ADDENDUM TO RFP DOCUMENTS

SOLANO COMMUNITY COLLEGE	ADDENDUM #02
	Project: Solano Community College District Vacaville Center HVAC Upgrade Project Project #18-010
	Date: February 28, 2018

Addendum # 02 – The following clarifications are provided based on questions received and must be added/considered when completing your submittal: Acknowledgement of receipt of this **ADDENDUM** is required in the proposal’s cover letter of introduction. Please clearly note the addendum date and number.

5 TYPICAL STRUCTURAL PENETRATION
3" = 1'-0"

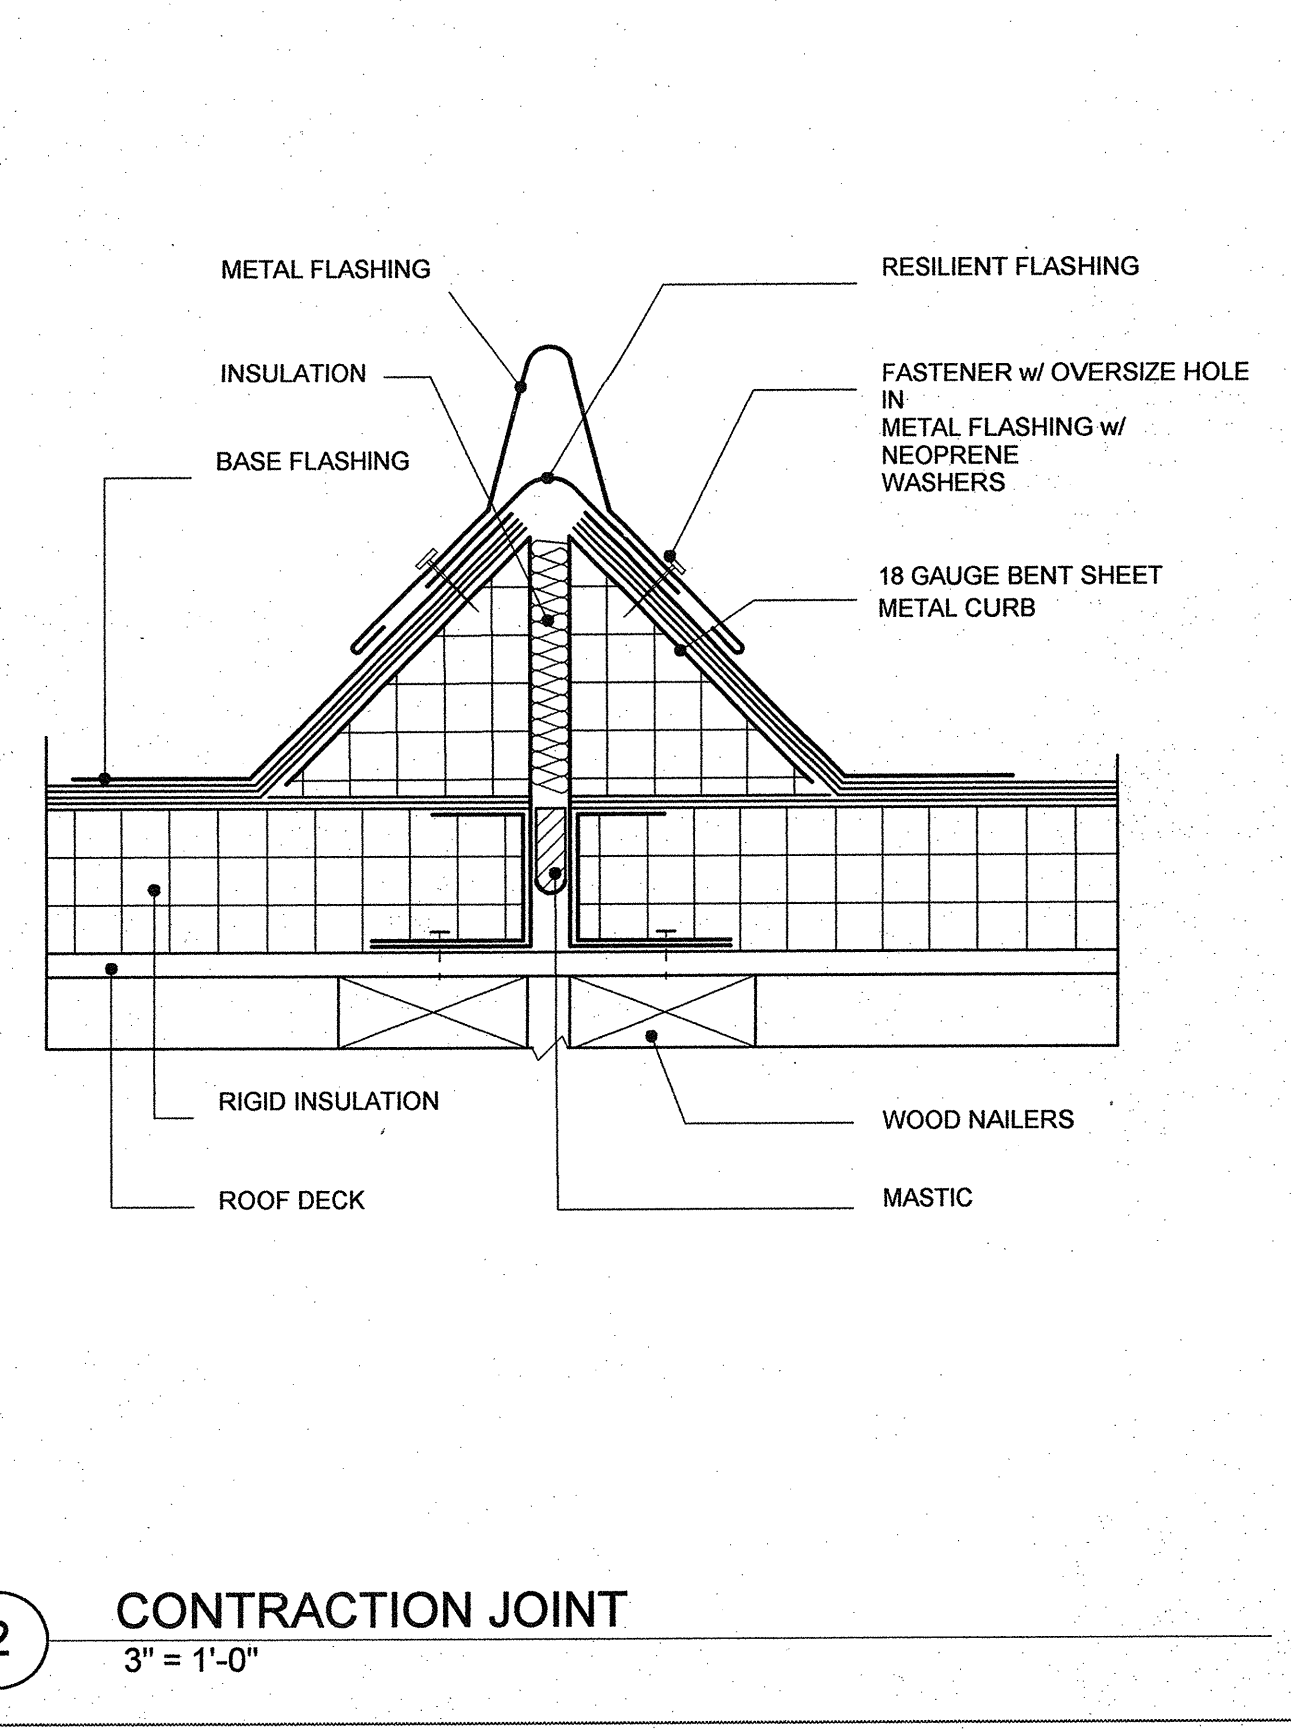
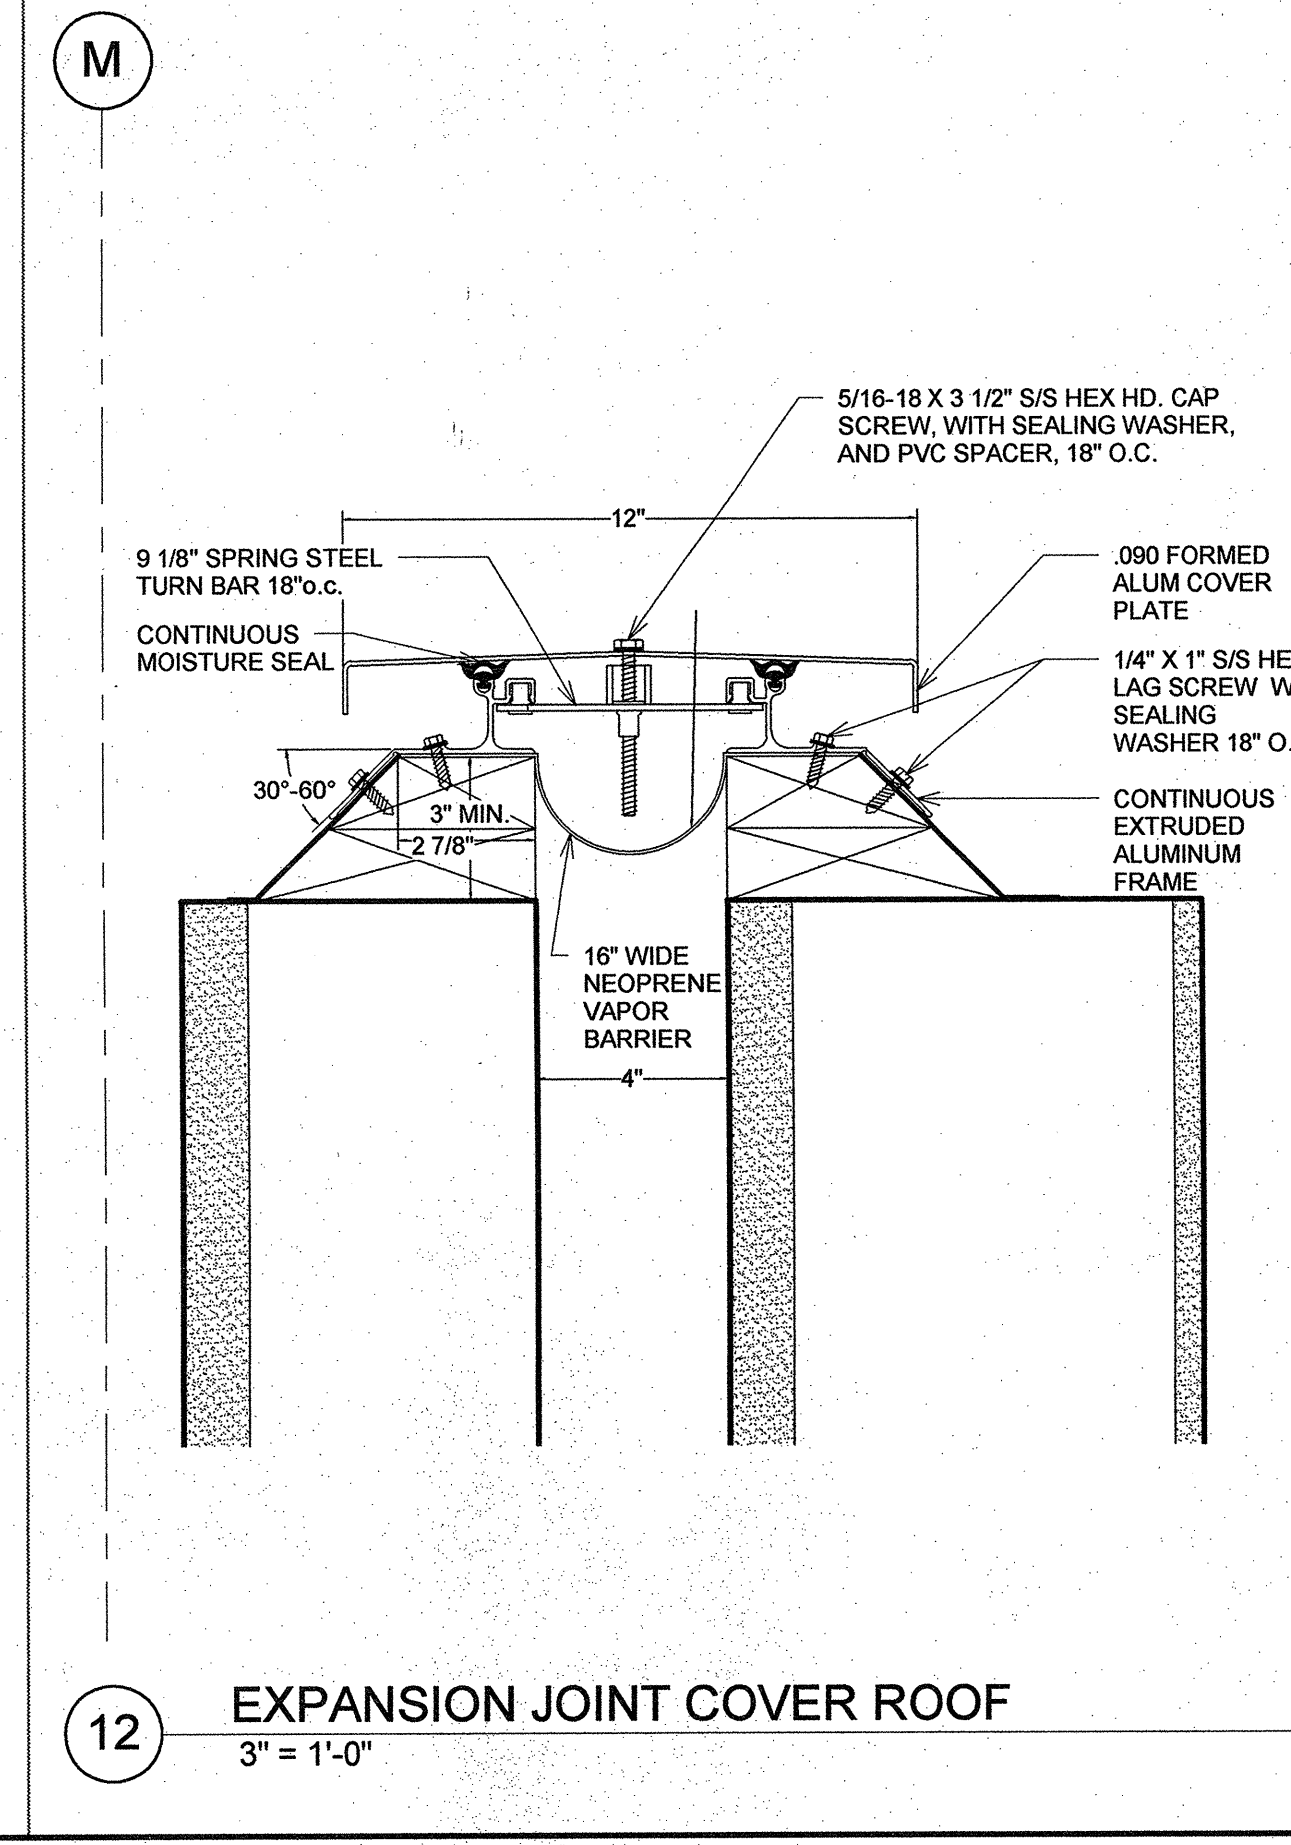
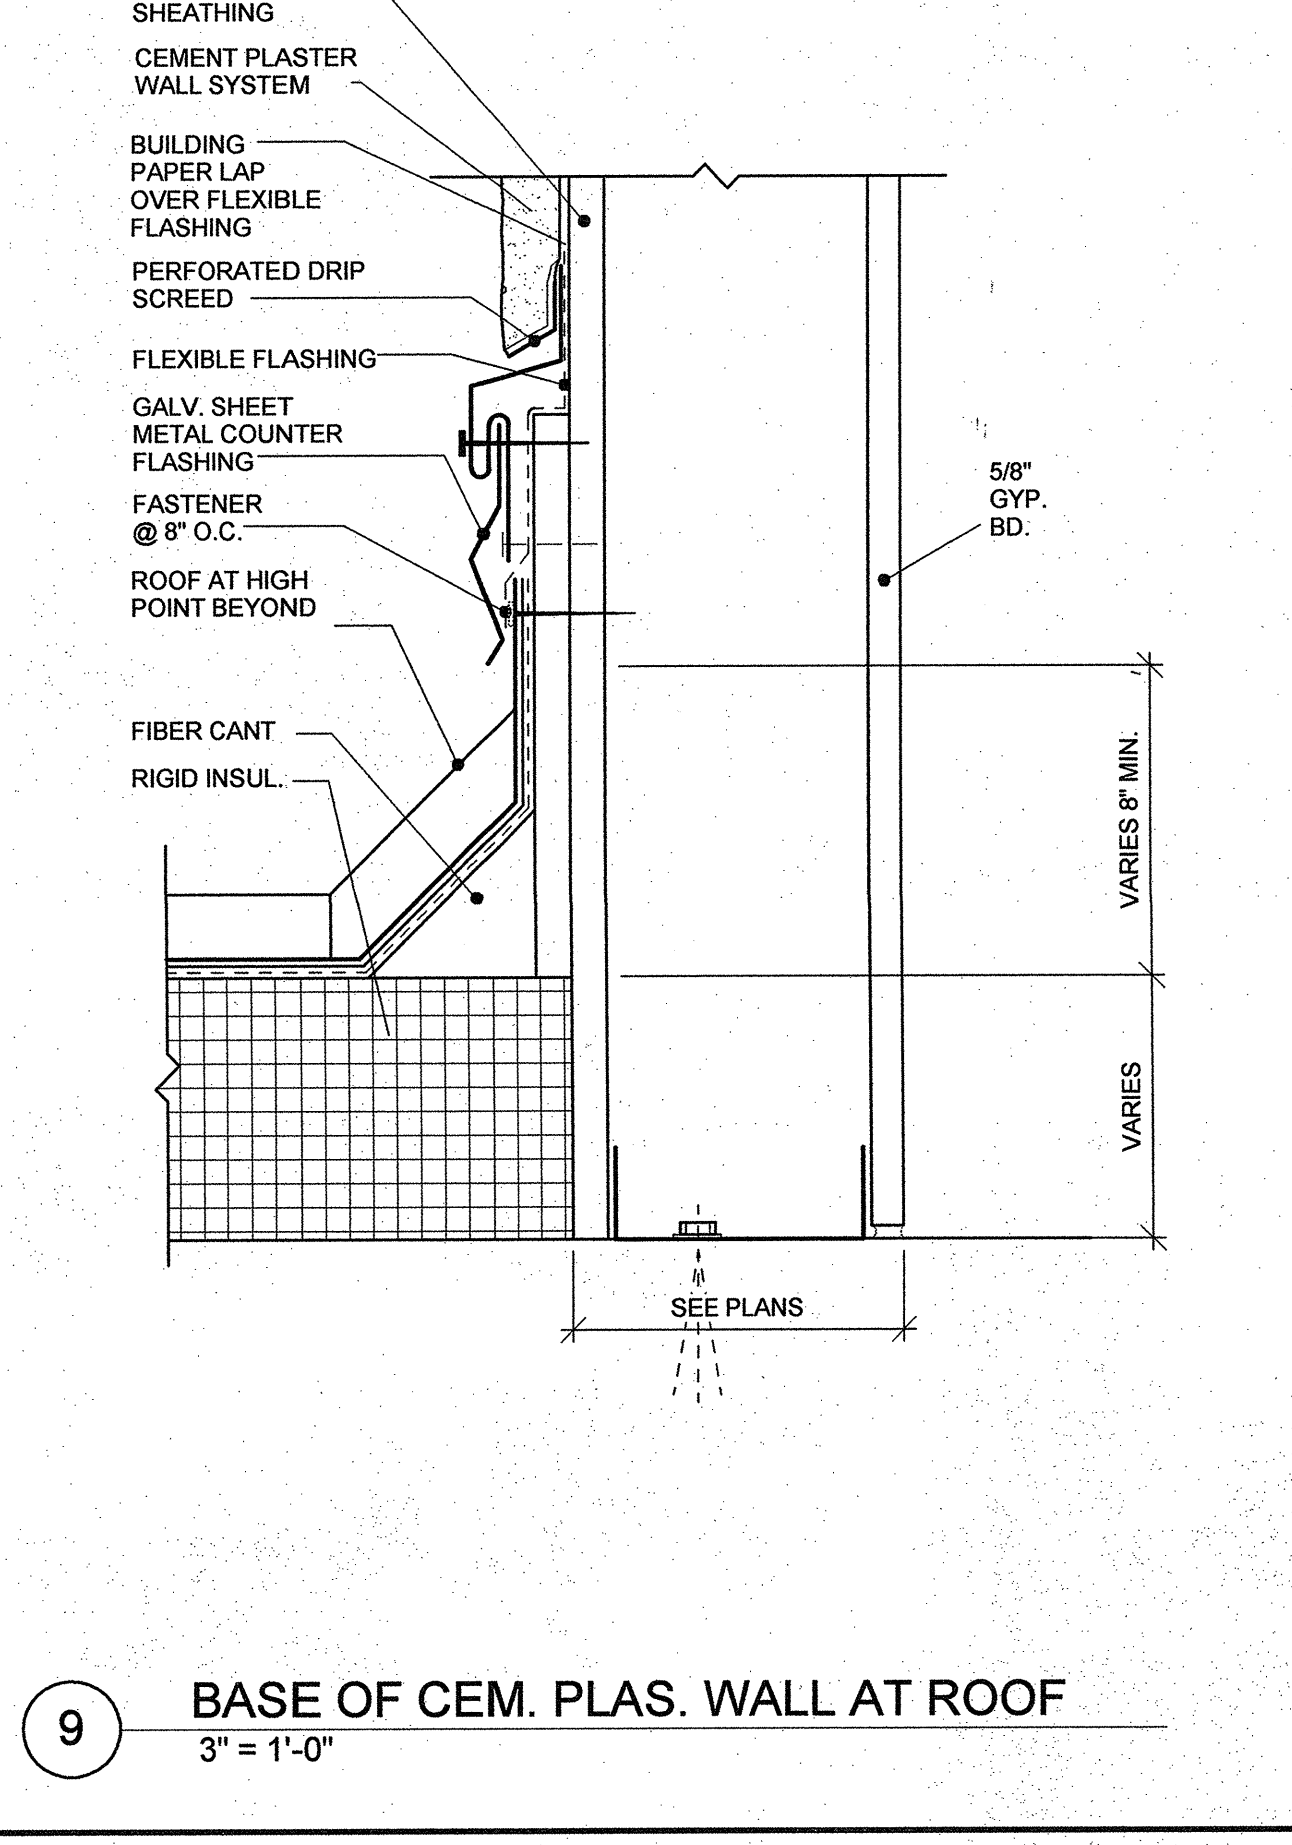
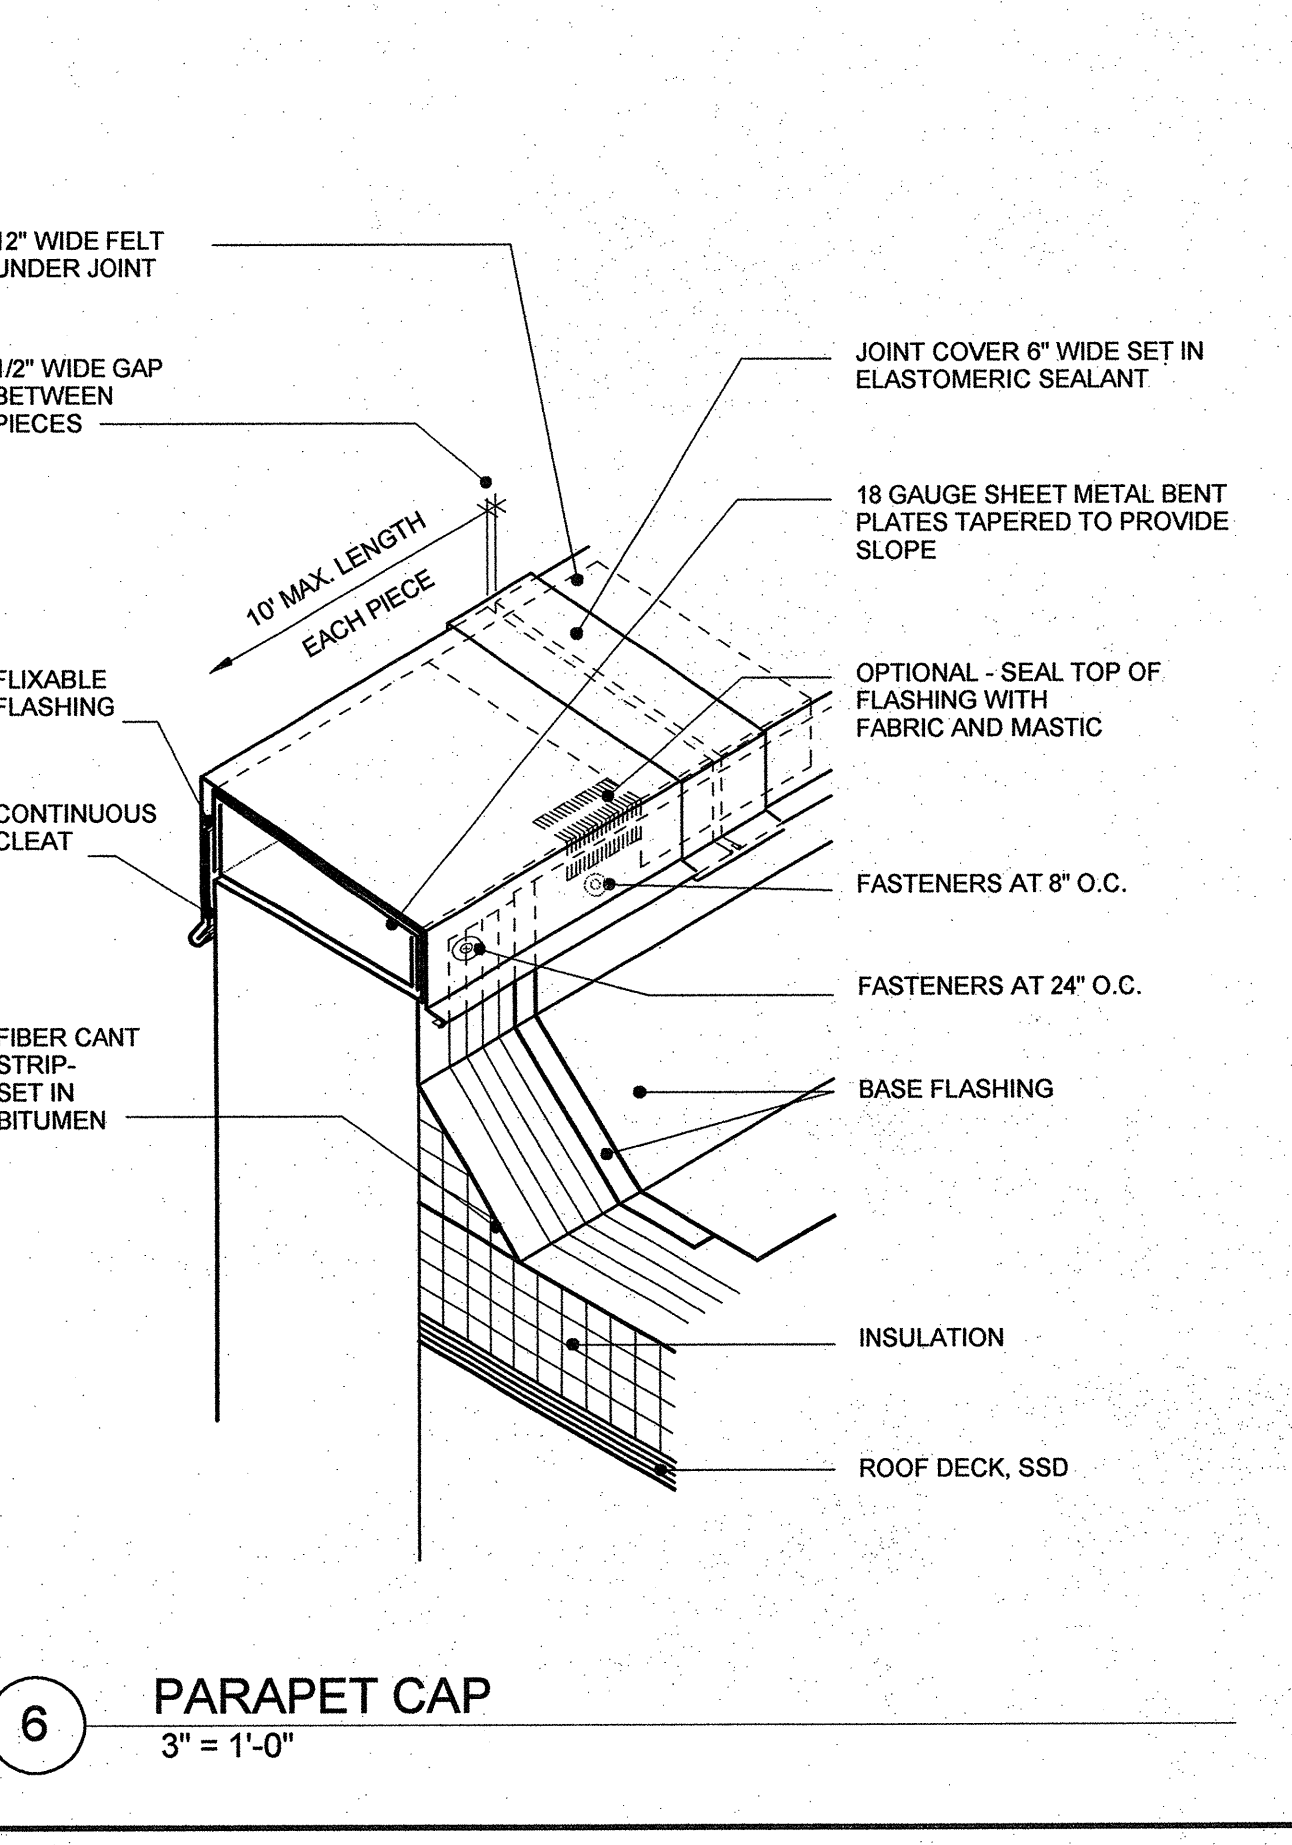
QUESTION –During the job walk it was determined that the existing roof system is fully tapered by rigid insulation ½” in 12” slope with a minimum of 6” at drains but not shown on the drawings. Please confirm and provide new details identifying existing insulation.

ANSWER – Please see the attached As-built drawings: A8.51, A8.52 & A8.53 for all the info of the existing roof condition (see attached).
